### SHOREHAM NUCLEAR POWER STATION

SNRC-1698

Revision of Emergency Preparedness Plan  
Shoreham Nuclear Power Station - Unit 1  
Docket No. 50-322

FIGURE 5-2  
P. 26  
REV. 8  
1/08/88

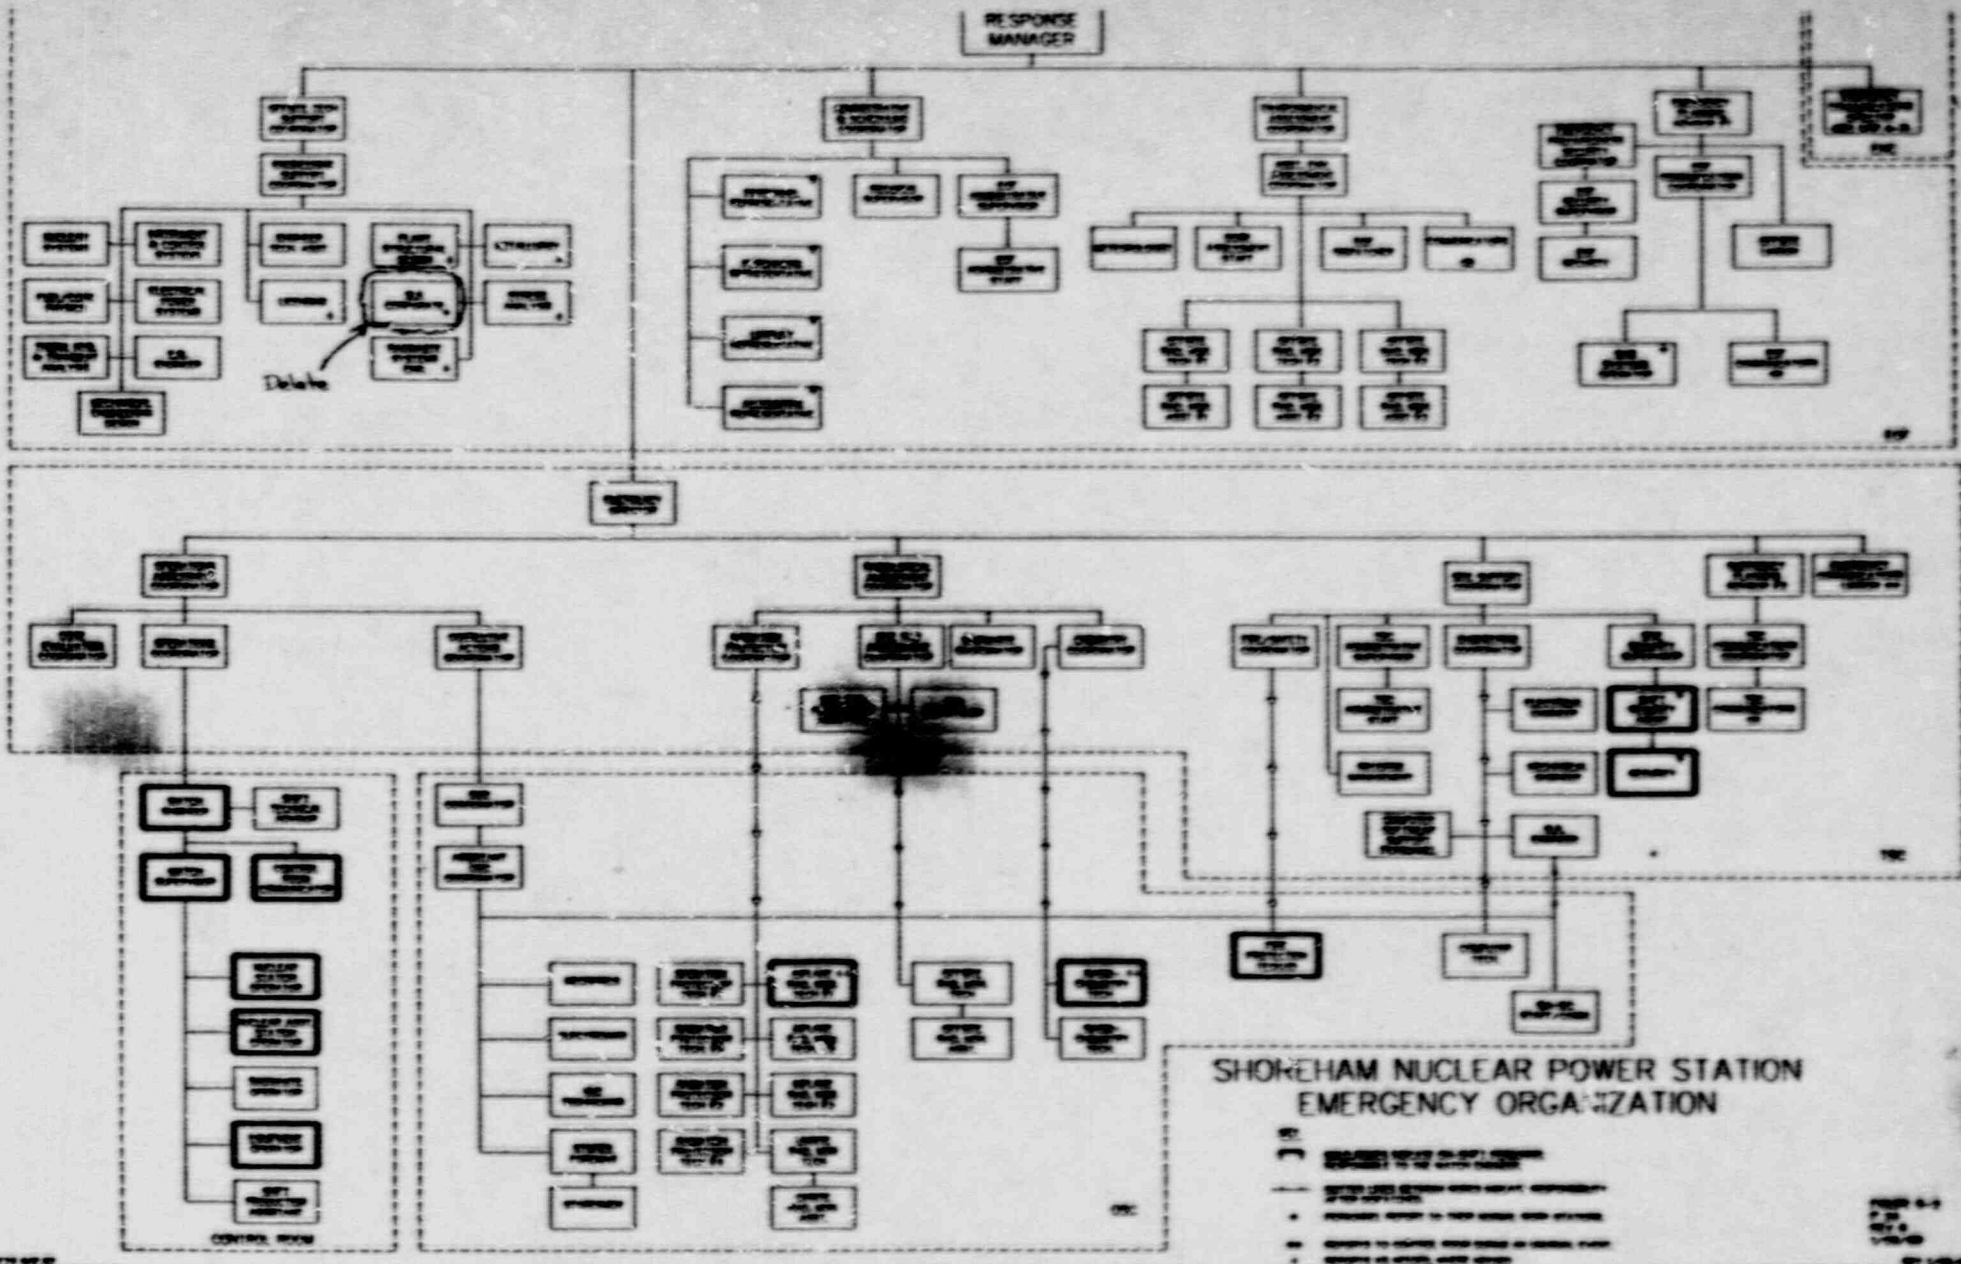
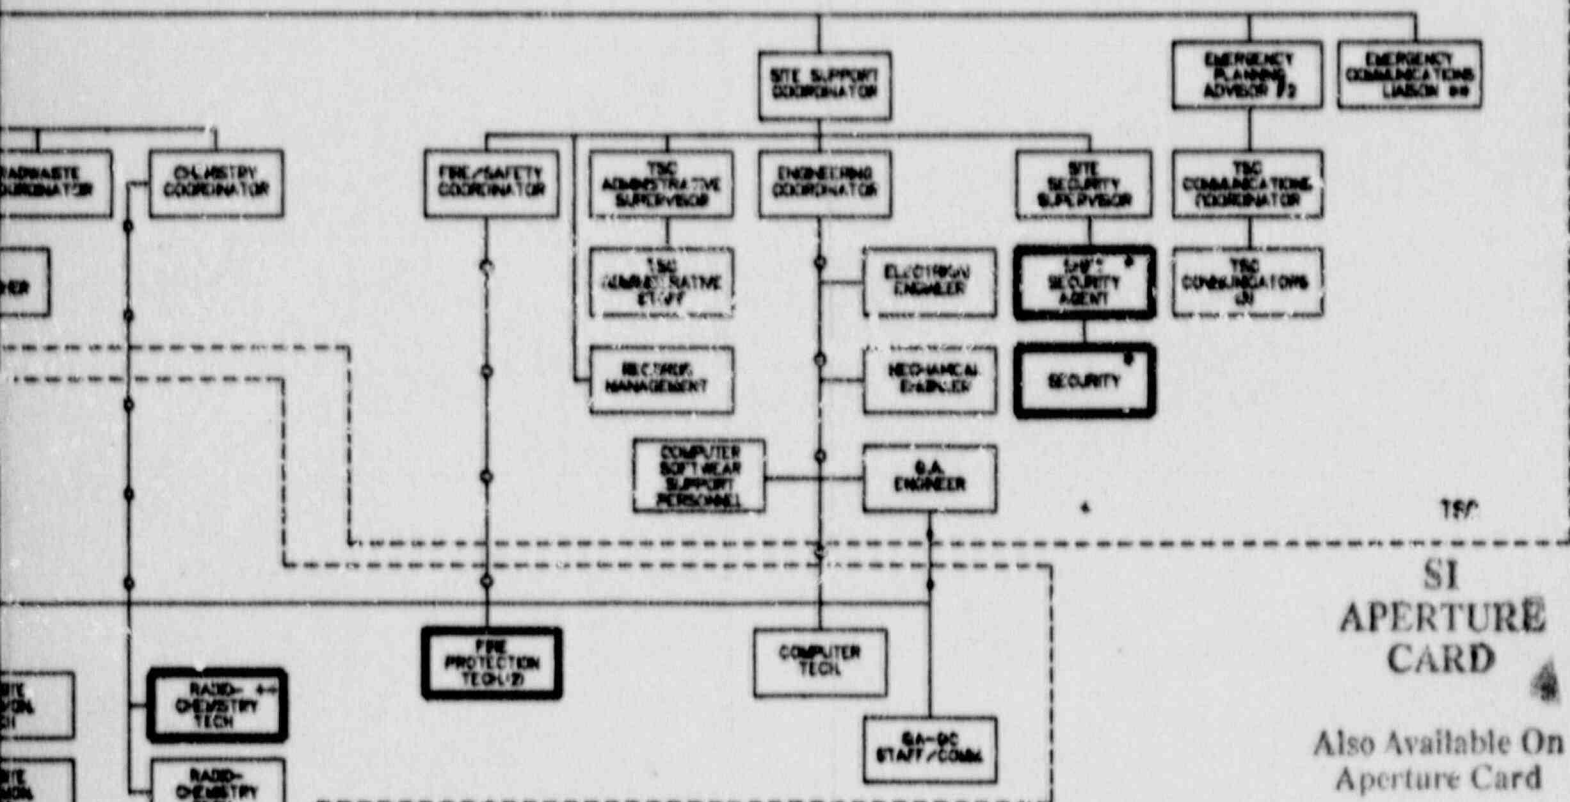
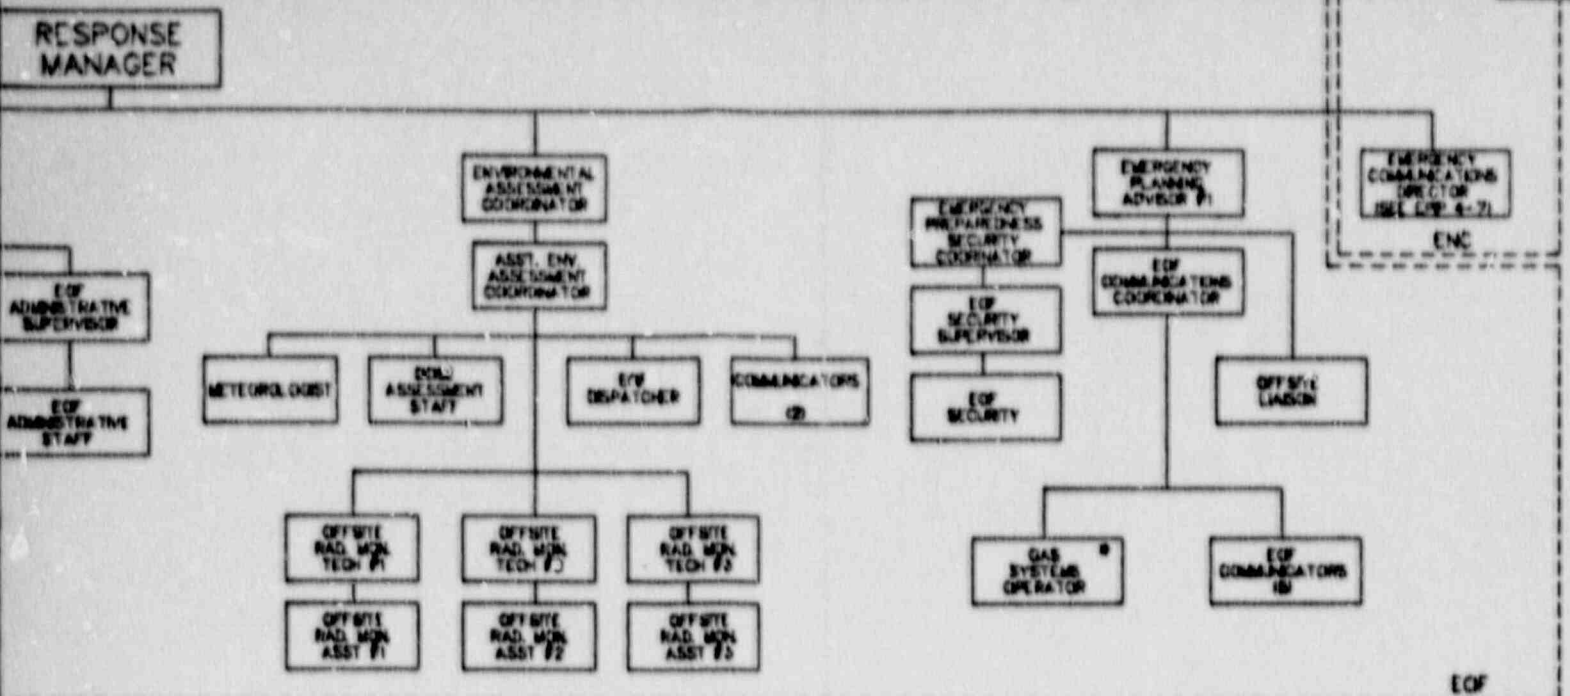
In accordance with 10CFR Part 50, Appendix E., Section V and 10CFR50.4, LILCO is forwarding a change to the Shoreham Nuclear Power Station Emergency Preparedness Plan ("Plan"). As detailed in the attachment to this letter, this change removes the position of Corporate Quality Assurance from the Emergency Response Organization (ERO).

This change is being made because, with SNPS in a defueled condition, the functional requirements of the position are no longer needed in the ERO. Personnel who previously filled the Corporate Quality Assurance position have been reassigned to other positions in the ERO.
